**Constellation  
Energy Group**  
Nine Mile Point  
Nuclear Station

August 15, 2003  
NMP2L 2096

**SUBJECT:           Nine Mile Point Unit 2  
                          Docket No. 50-410**

**License Amendment Request Pursuant to 10 CFR 50.90: Revision of  
Reactor Pressure Vessel Pressure-Temperature Limits**

Figure 3.4.11-1 (Page 1 of 1)  
Non-Nuclear System Leakage and Hydrostatic Testing Curve

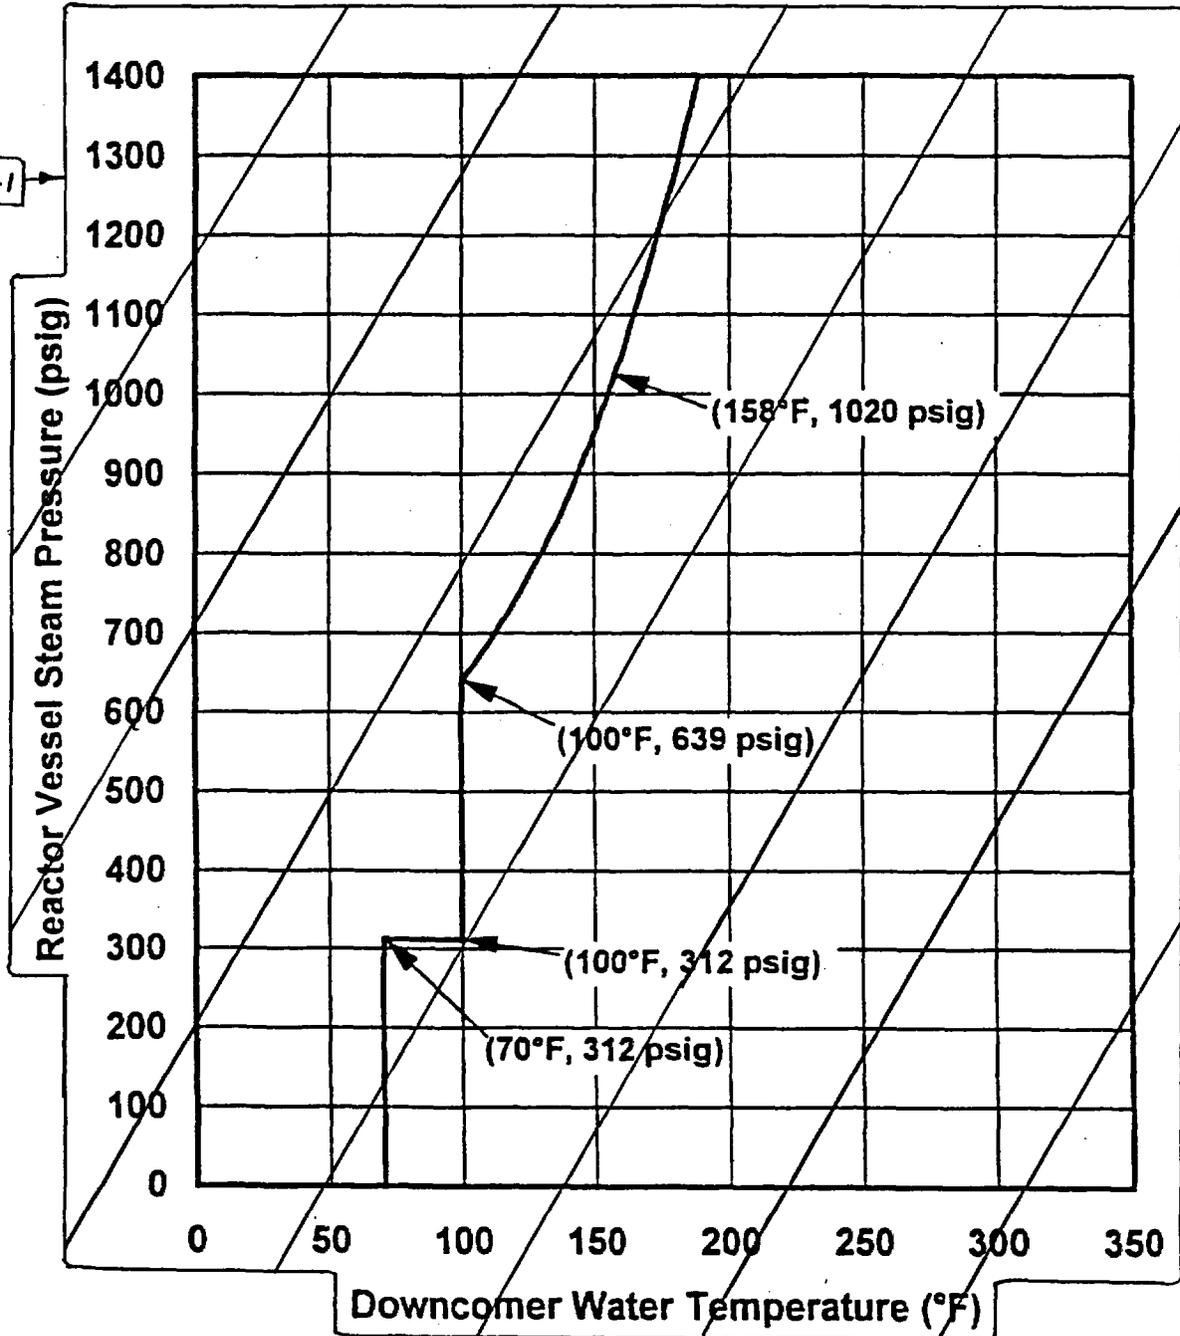
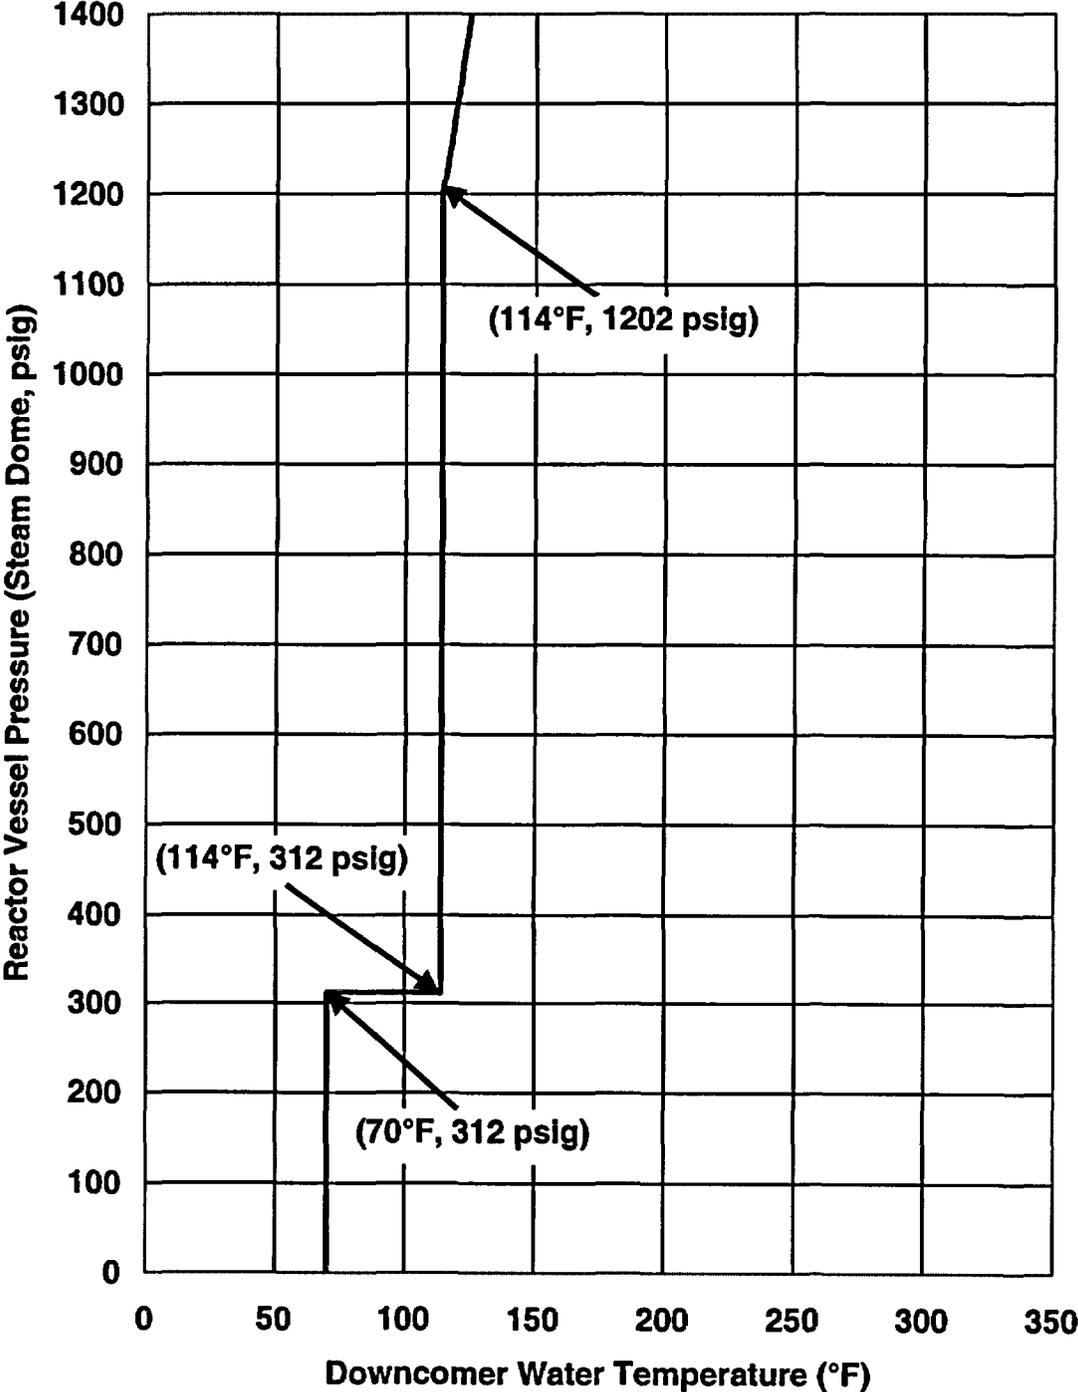
TS Figures 3.4.11-1 through 3.4.11-5 are being replaced with new figures to provide revised (recalculated) RCS P-T limit curves. The revised P-T limit curves will be valid for up to 22 EFPY and are applicable to system leakage and hydrostatic testing and RPV heatup and cooldown during reactor core non-criticality (non-nuclear) and criticality (nuclear) conditions.

INSERT  
FIGURE 3.4.11-1

Figure 3.4.11-2 (Page 1 of 1)  
Non-Nuclear Heatup Curve

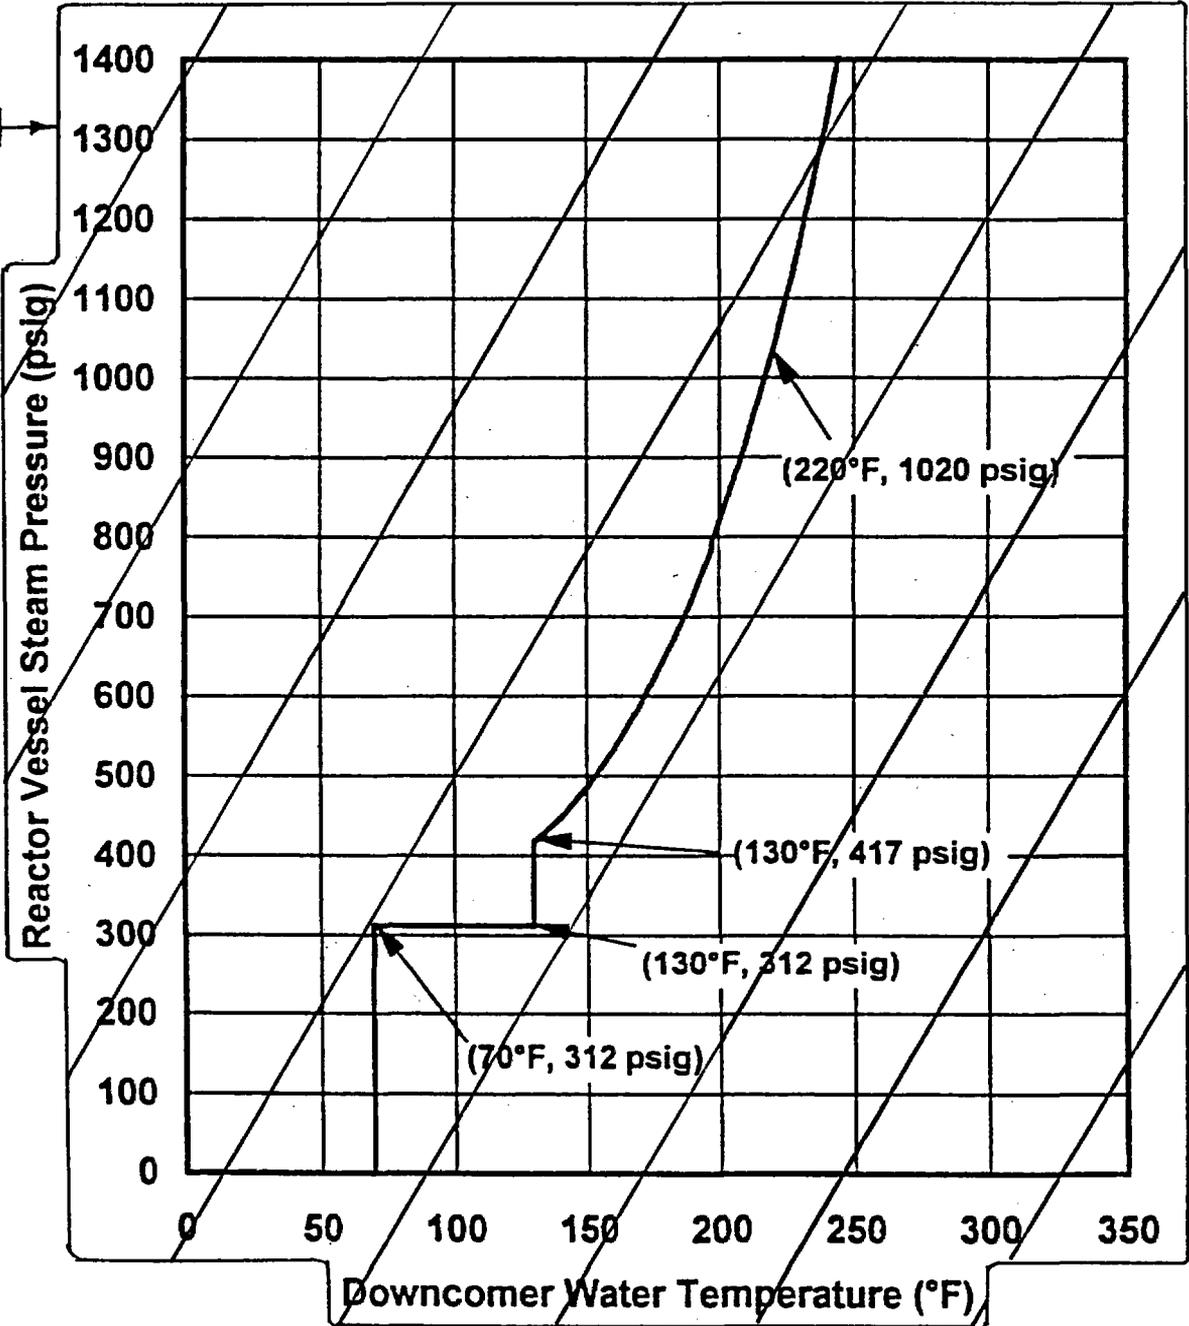
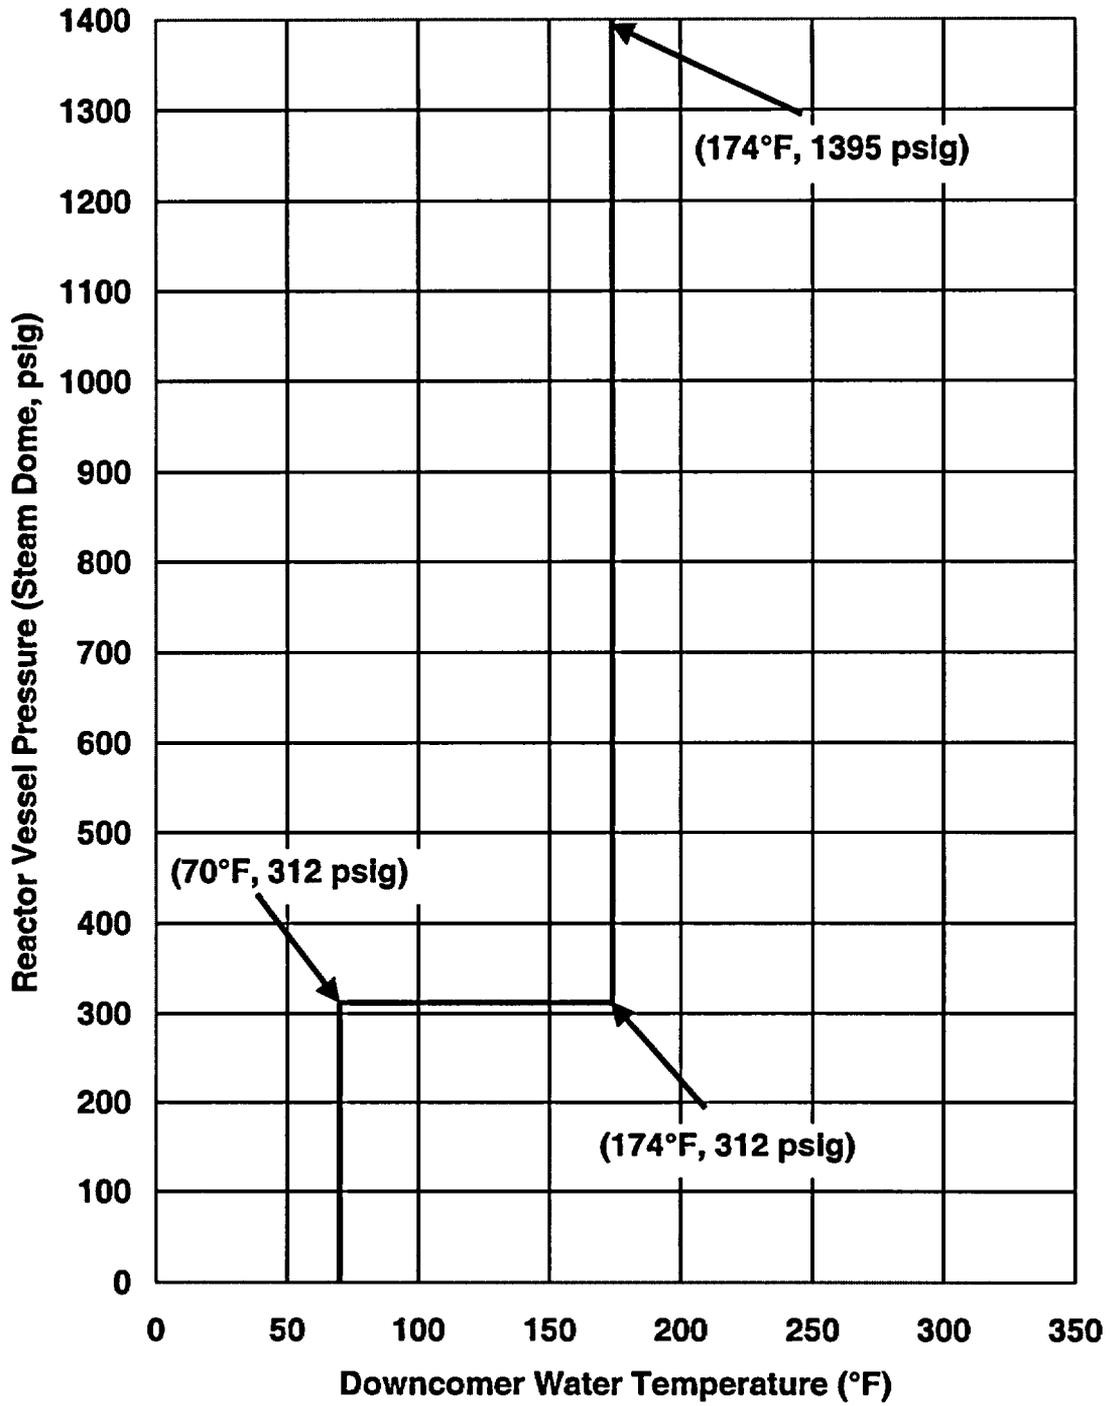
INSERT  
FIGURE 3.4.11-2

Figure 3.4.11-3 (Page 1 of 1)  
Non-Nuclear Cooldown Curve

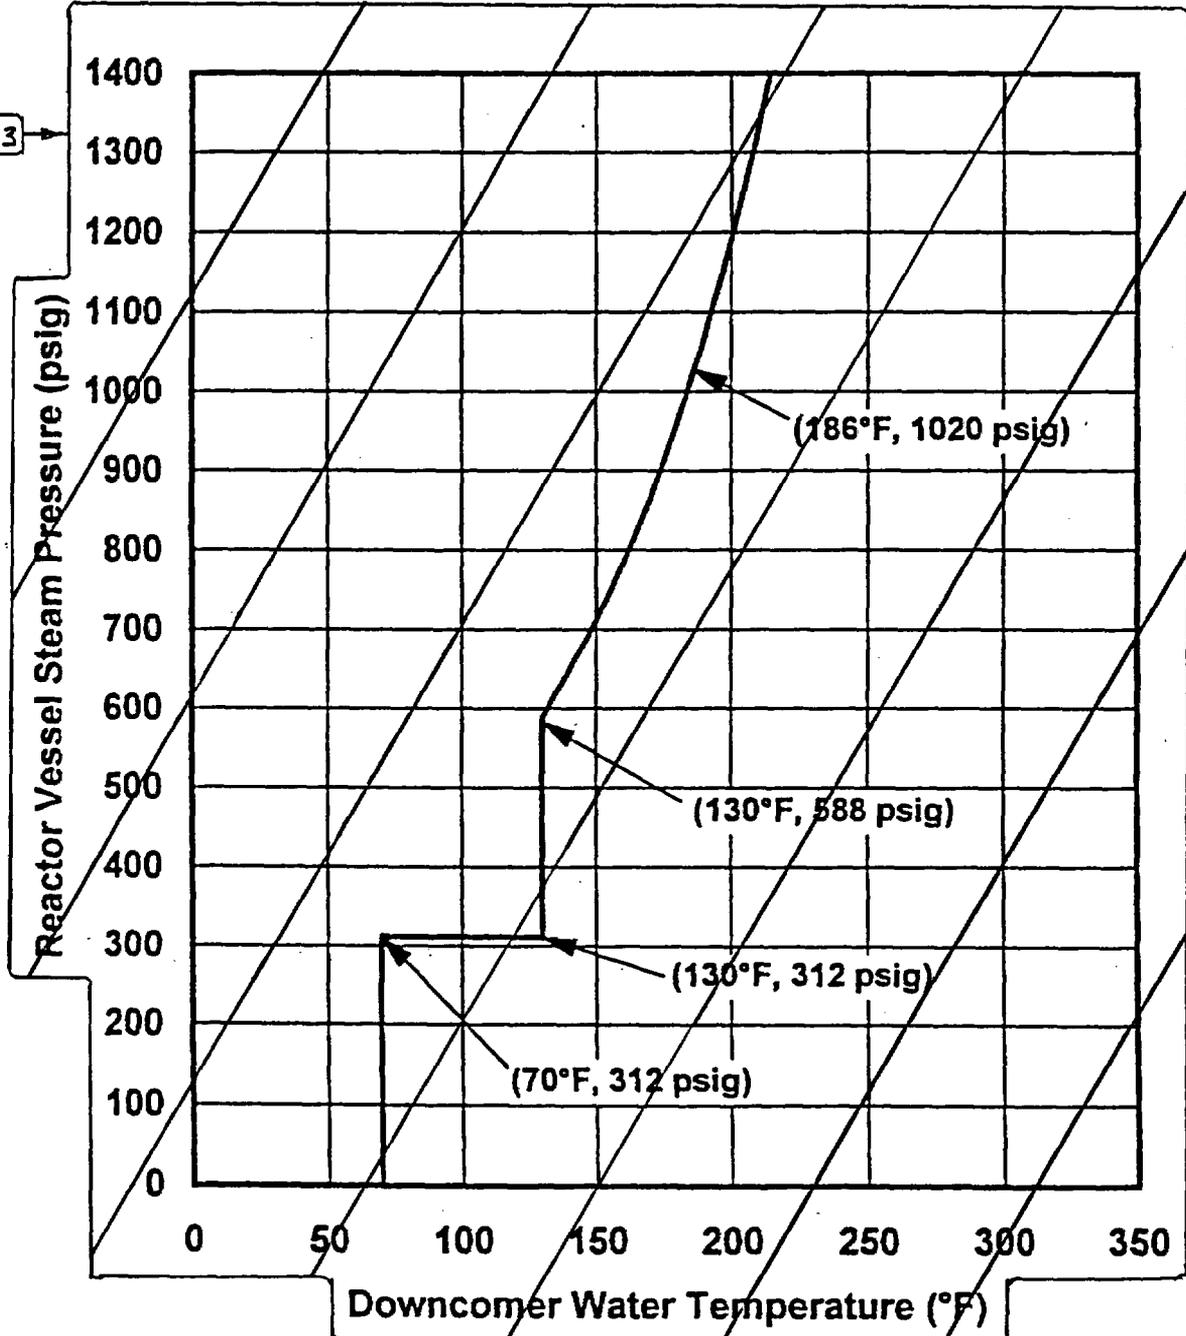
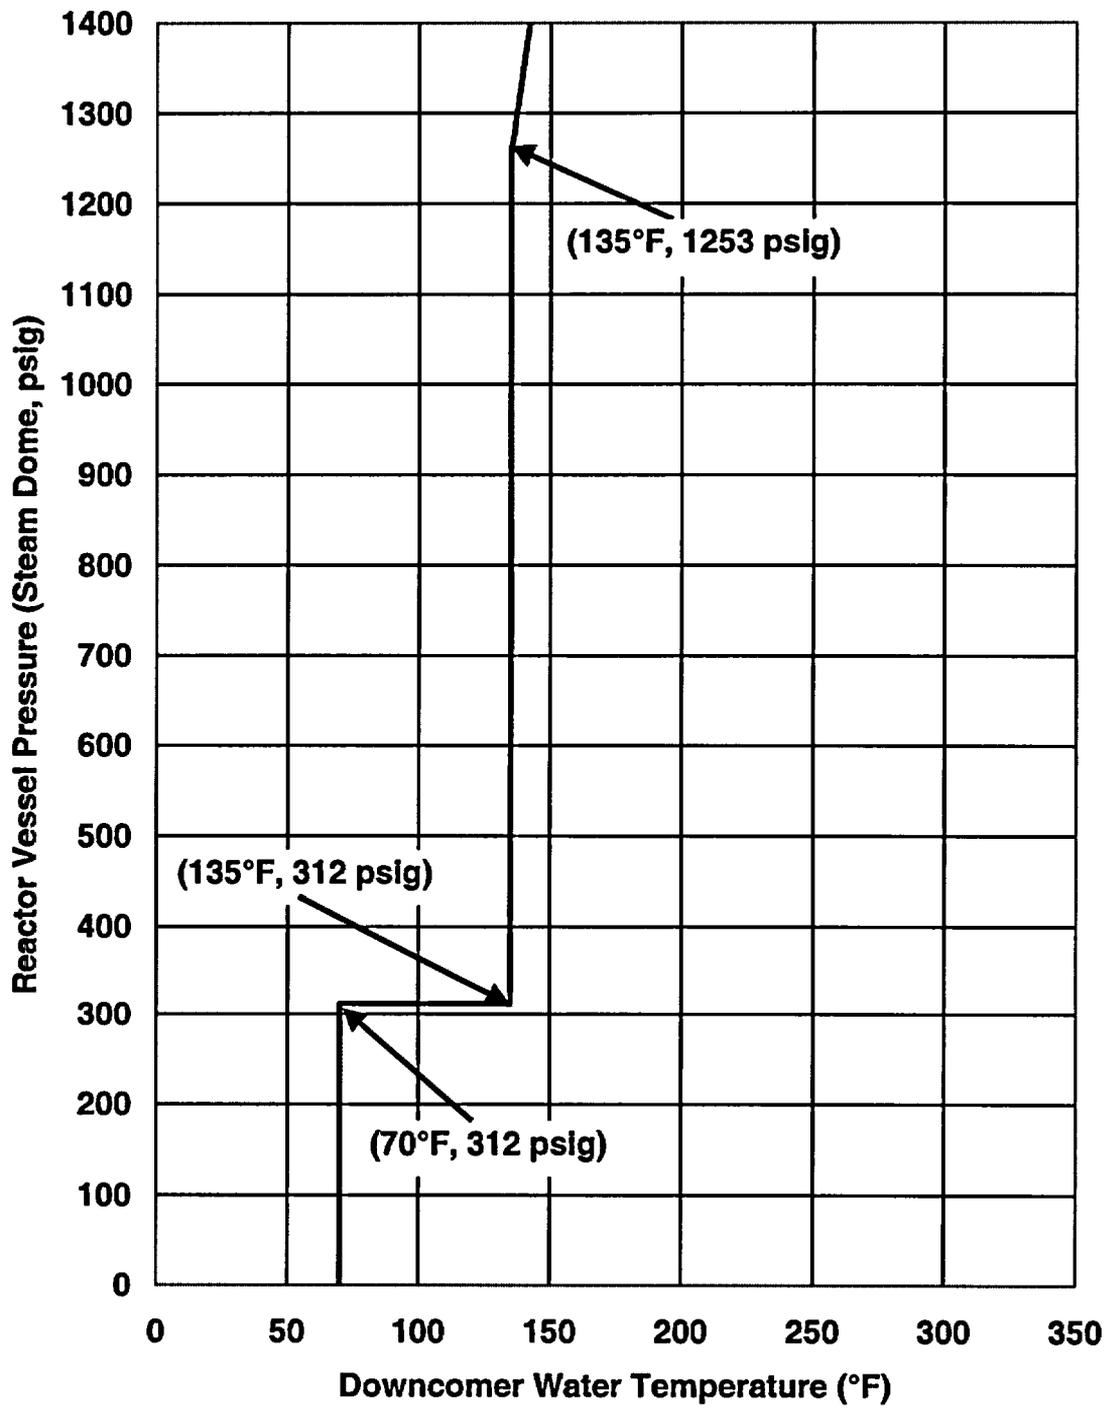
INSERT  
FIGURE 3.4.11-3
